FINAL
ENVIRONMENTAL IMPACT REPORT

An Addendum to the Draft
Environmental Impact Report

Castle Highlands (formerly
Park Properties) Subdivision

File No. ER 78-106
Ref. No. Tract 4084

Figure No. A

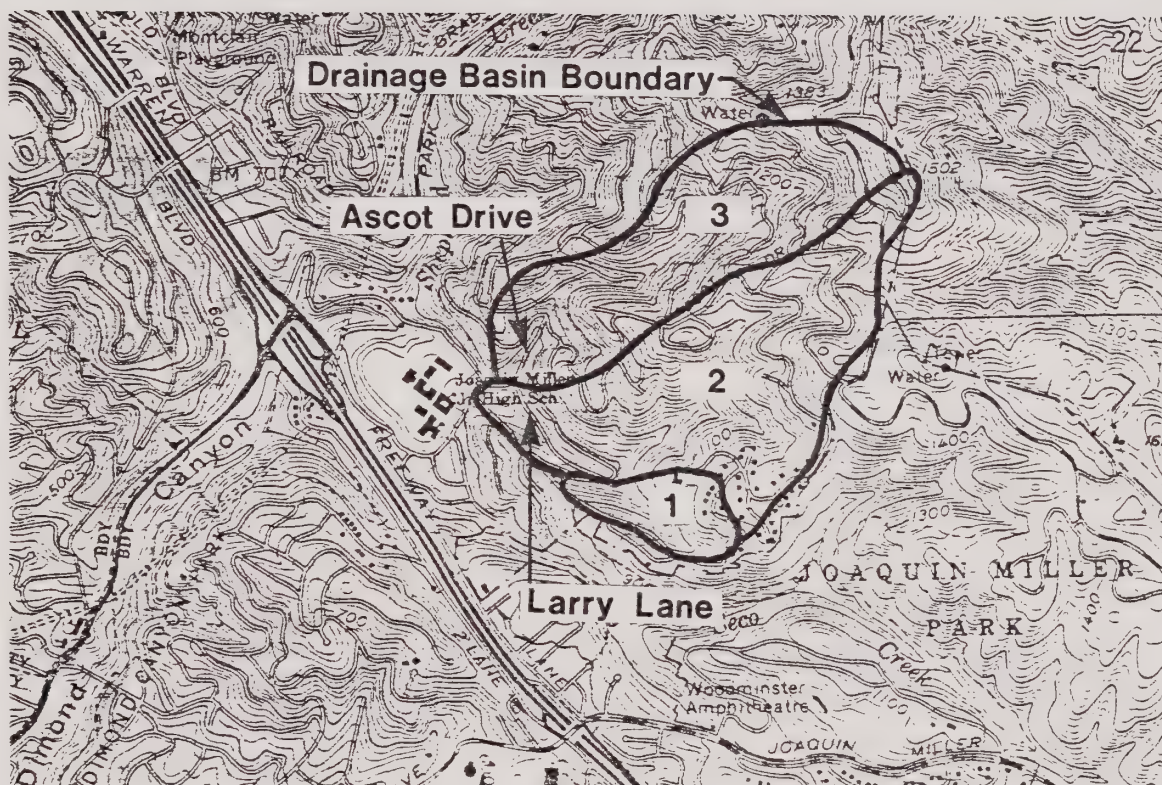
Comment: The Draft EIR states that the proposed development would not contribute significantly to increase runoff. A large number of commentors doubt that runoff would not increase and that previous flooding problems could be intensified by the implementation of the proposed project.

Response: * In 1962, during strong storms, which constituted the 100 year storm event, flooding occurred in the project area. Damage to property was recorded by the Oakland Department of Public Works at

the intersection of Larry Lane and Ascot Drive, and some overflows might have occurred at Larry Lane and Mastlands Drive, although the office of Public Works does not have any records to that effect, (Ray Feeley, Oakland Office of Public Works, September 26, 1979). Development of the project site could impact not only the Larry Lane/Mastland intersection, but also the Larry Lane/Ascot Drive intersection, since runoff from the site flows into the creek along Larry Lane which meet another creek by Ascot Drive. Three drainage areas have been identified as contributing runoff to the Larry Lane/Ascot Drive intersection. These areas are depicted in Figure A (following).

Development of the project site would result in an increase of impermeable surfaces over existing conditions. Impermeable surfaces cause more storm water to runoff instead of permeating through the soils. In addition, the velocity of the run off increases due to decrease in channel roughness. Thus the total time of concentration* decreases.

In estimating the change in runoff due to development, the Rational Method is customarily used, i.e., $Q = CiA$; where Q is the peak runoff rate, C is a dimensionless coefficient dependant on basin characteristics, " i " is the average precipitation intensity for a duration equal to time of concentration, and A is the drainage area.

If the project site were developed the C -coefficient would increase. The " i ", average precipitation intensity during time of concentration, would decrease, since the water would flow faster toward the point of discharge when the surface conditions change from a natural state to a more developed state. However, since the precipitation intensity, during time of concentration, decreases, peak flows at the point of discharge would increase. The velocity of the runoff is proportional to the roughness of the land surface. It is estimated that the roughness would decrease by a factor of about 3; thus the velocity would increase by about 3 times, which would result in a decrease in time of concentration of about 3 times. This would result in an overall increase in peakflows of about 50 percent. During heavy storms, this increase could cause runoff overflows near Larry Lane and Mastlands Drive intersection, as has happened in the past. Overflow at this location, however, would decrease the peakflow downstream (e.g. by Larry Lane/Ascot) where property damage was recorded in 1962.

The project site constitutes about 5% of the total drainage area discharging by the Larry Lane/Ascot intersection. (See Figure A).

#1

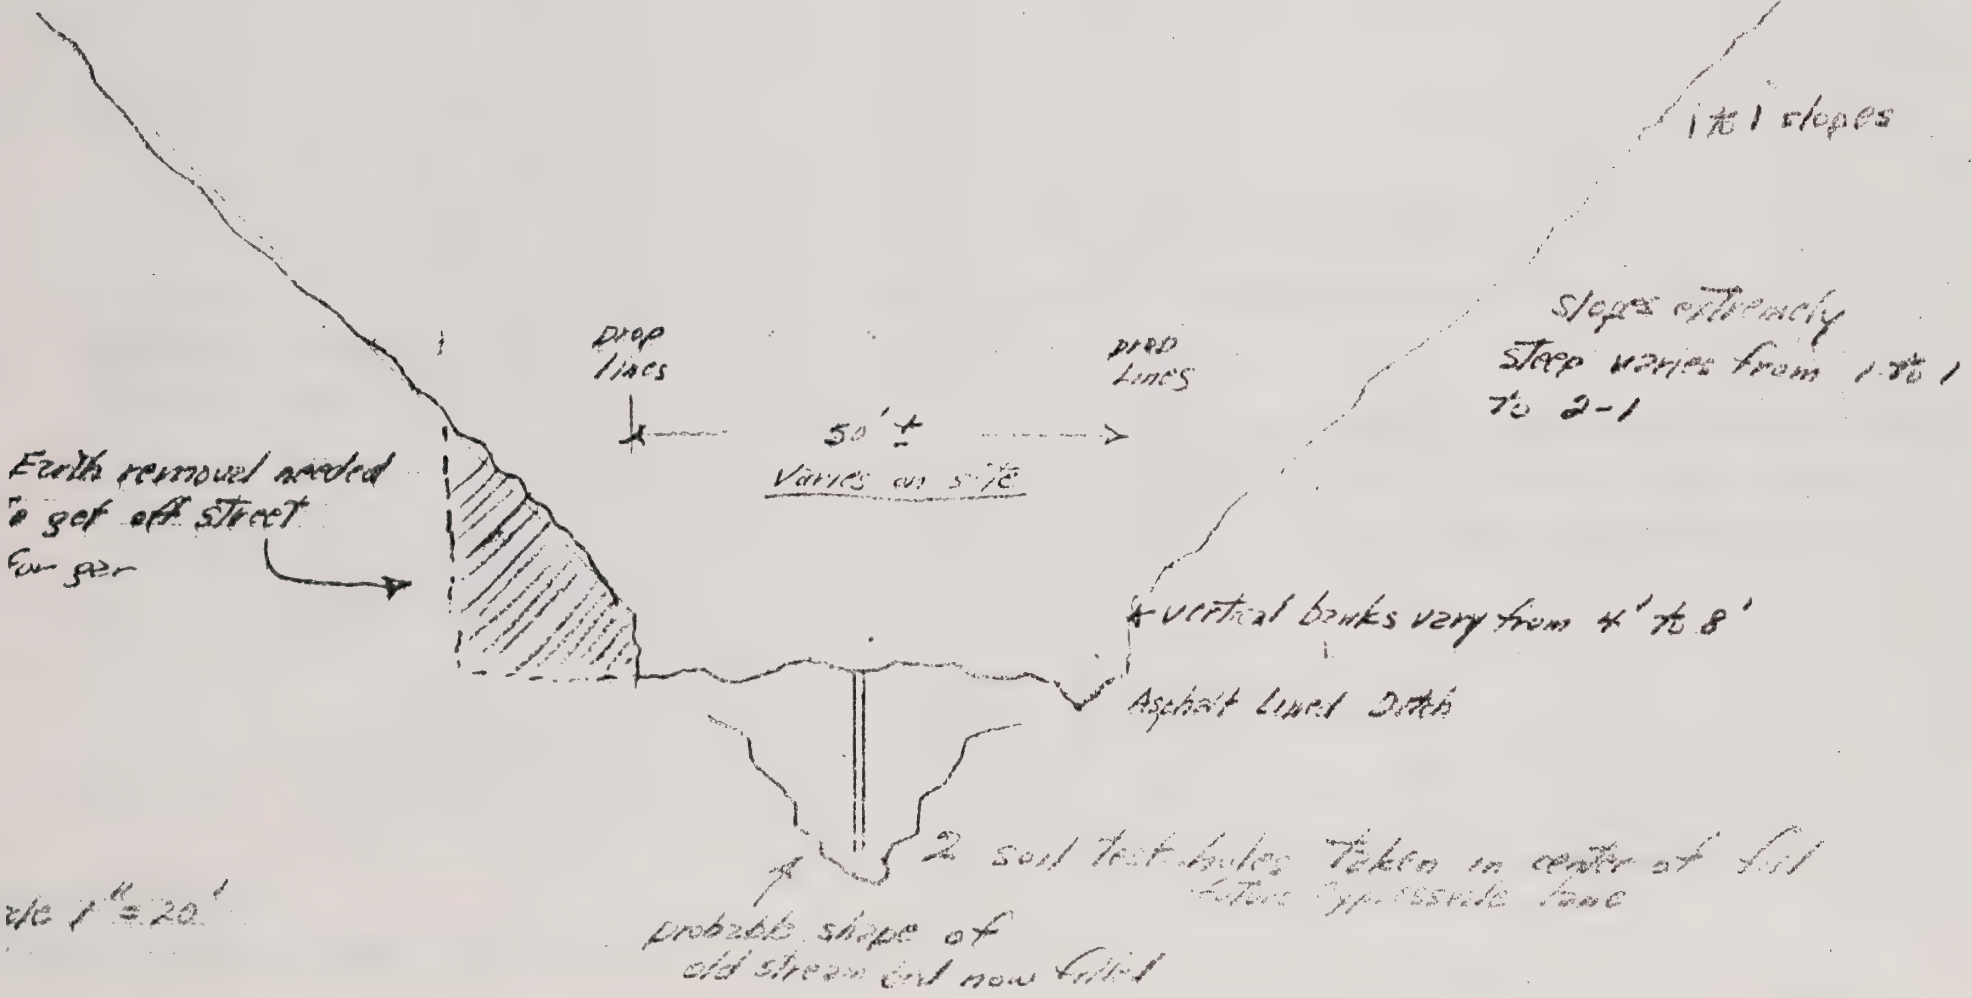
All the upslope lots 19, 20, 21, 22, 23, 24, 25, 26, 27, 28, 29 will require massive earth removal in order to get off the road, the grades are for the most part well within variances from specified 25' set back from property line. (Please see drawing #1)

#2

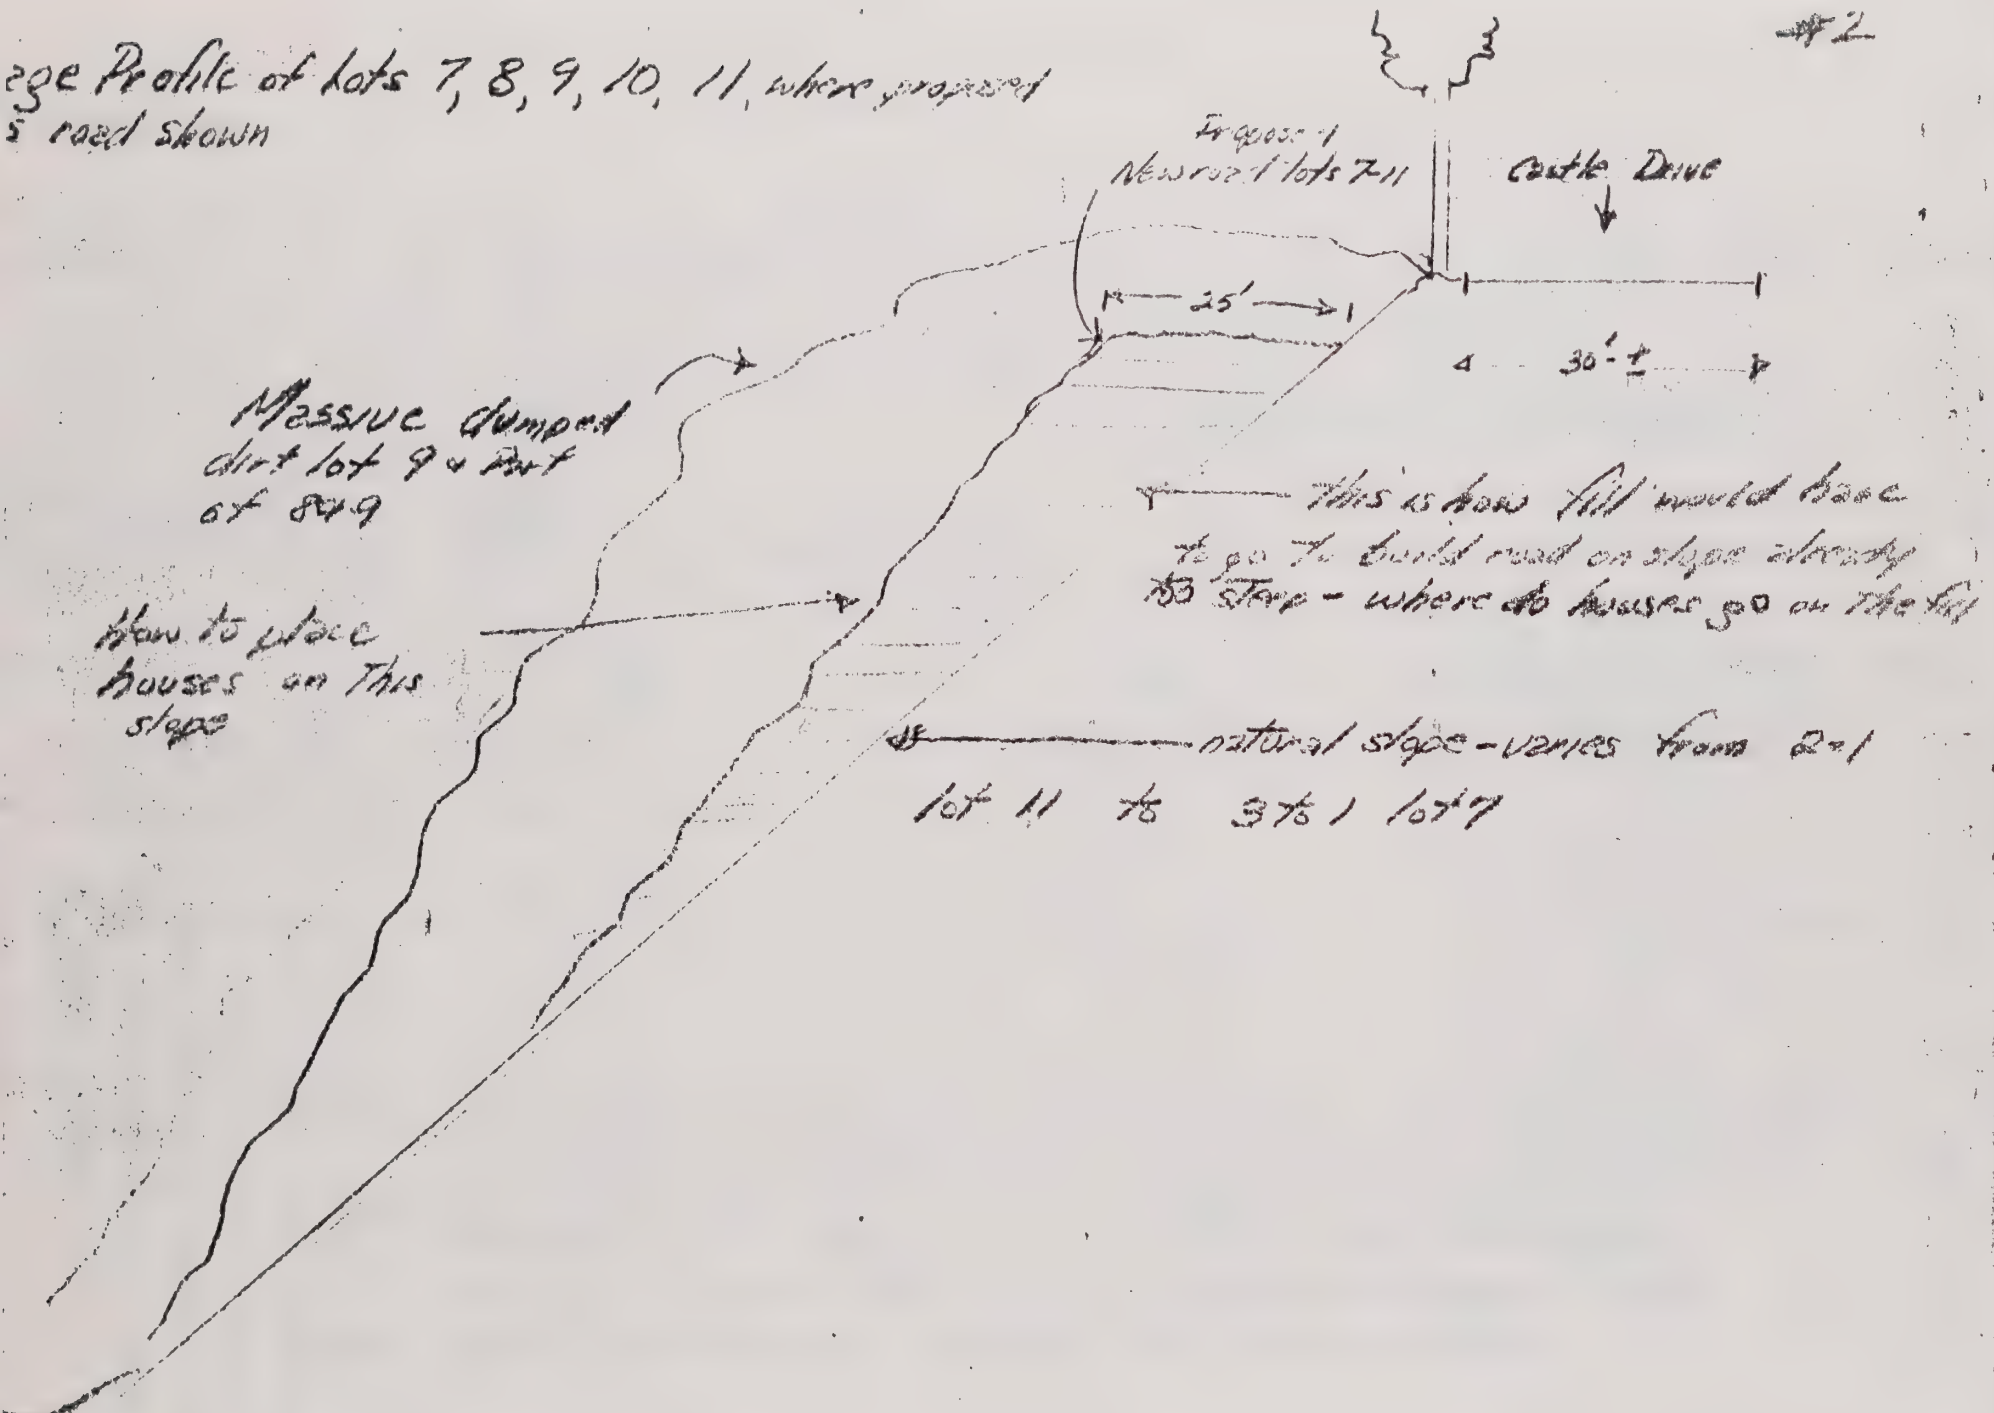
Probably every downslope lot along Castle Drive would require a set back variance from 25' required in order to get off the street practically & economically. This would be done either by individual builders or the developer (who probably does not intend to build houses himself). These lot are all very steep.

ASSESSOR'S MAP 48D

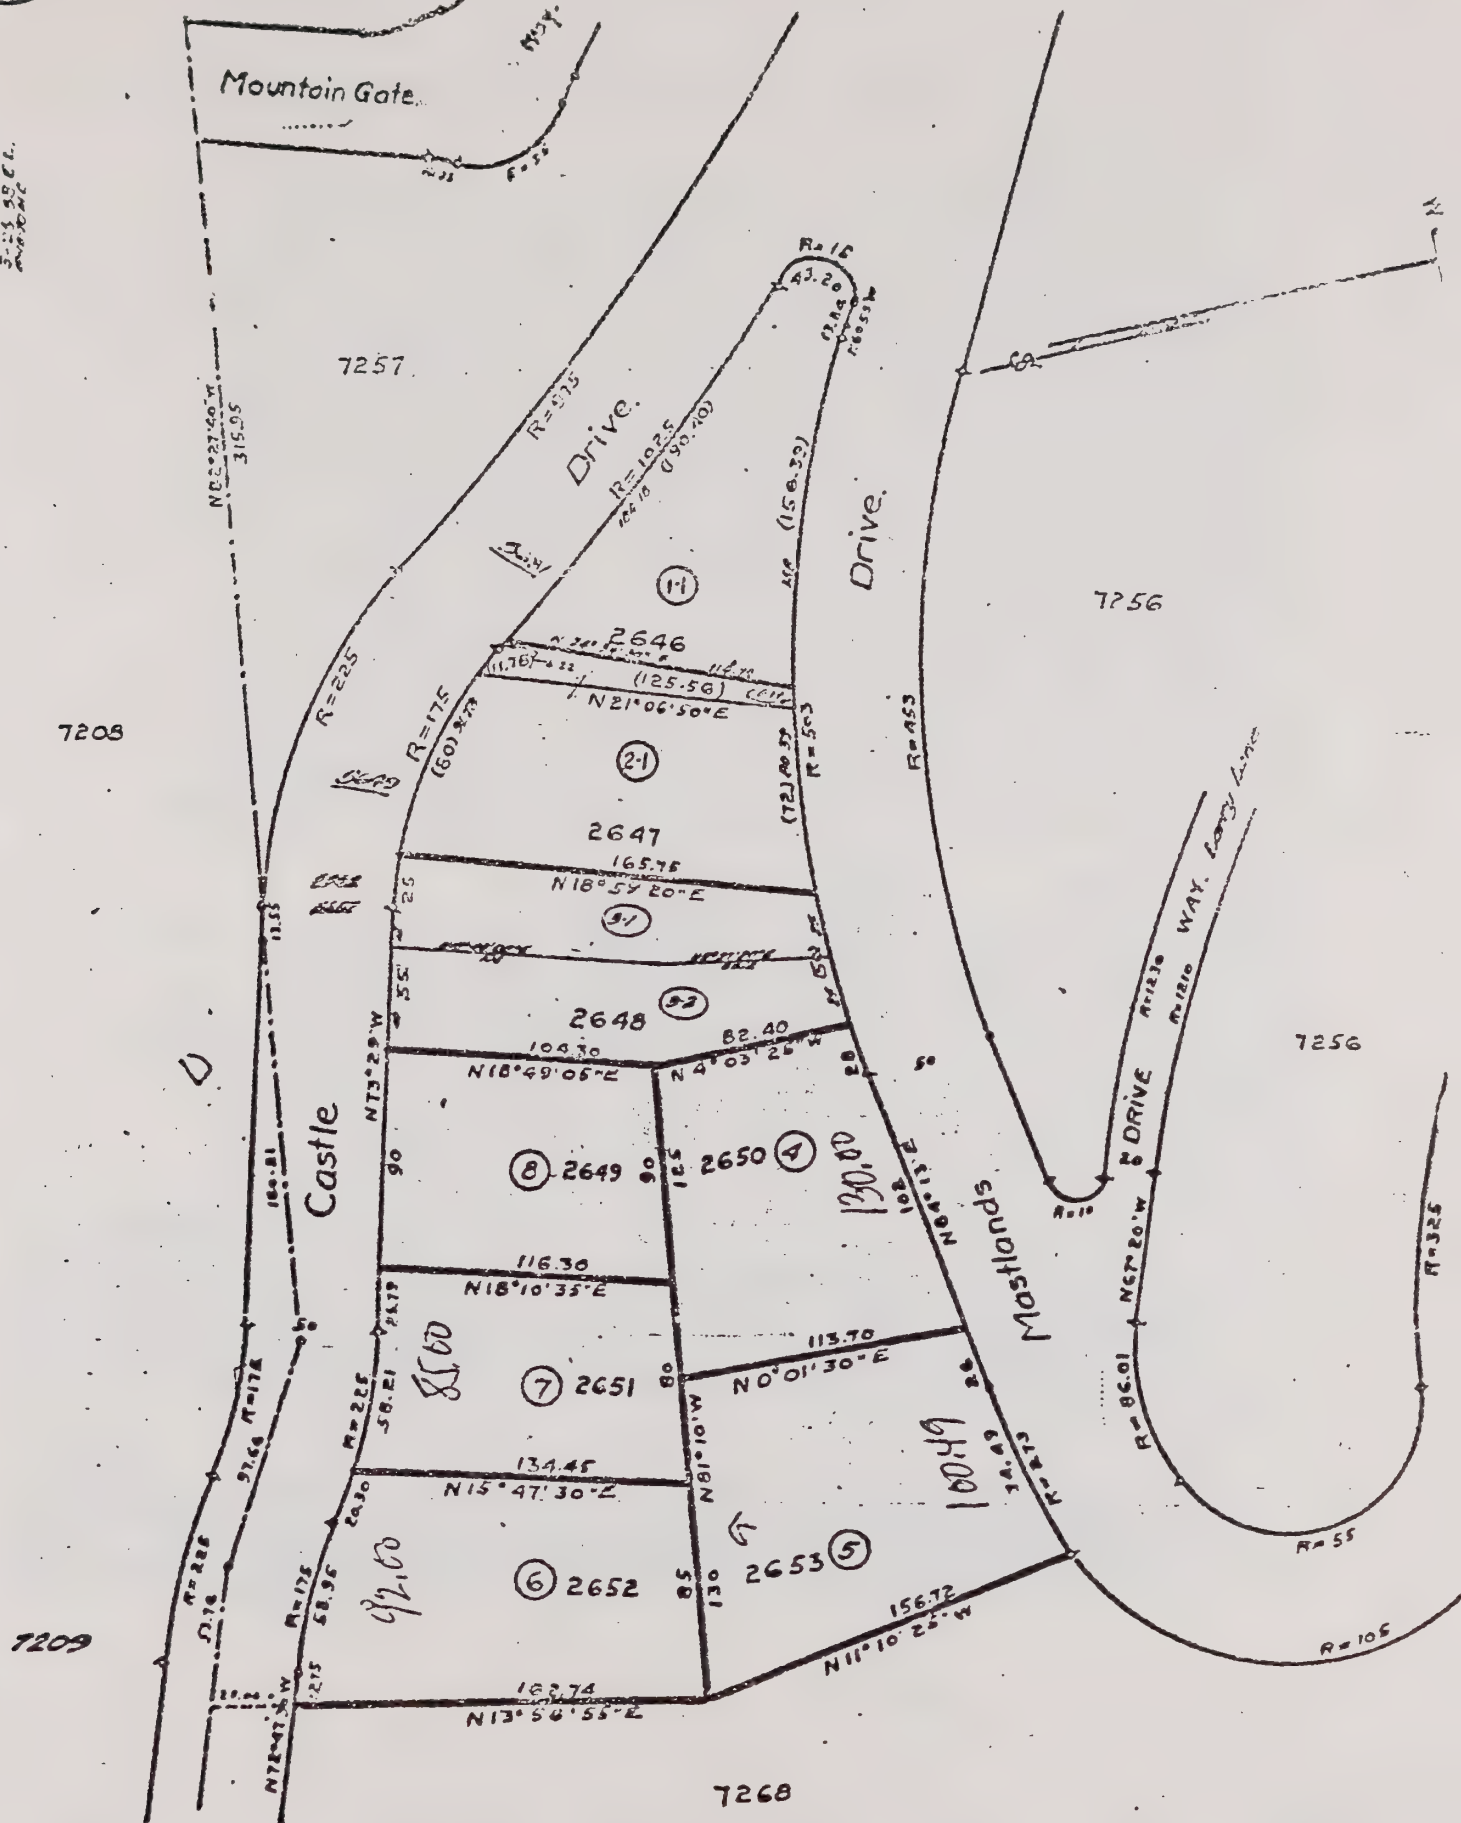
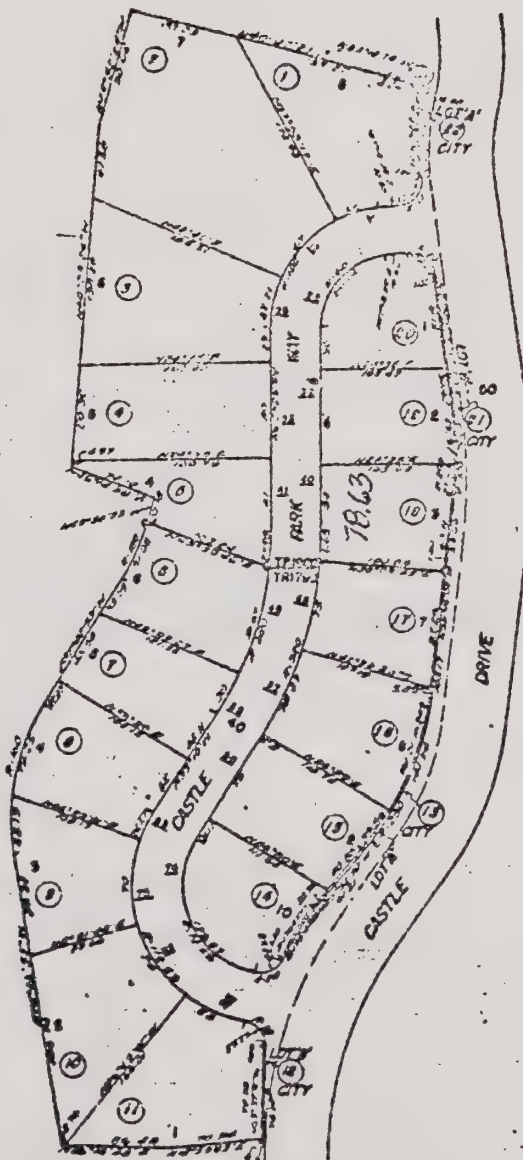
Comment: Mr. Vanier points out that the site plan in the Draft EIR does not correlate with Assessor's Map 48D.

Response: The site plan submitted to the consultants for environmental review, is depicted in Figure No. 3 in the Draft EIR.
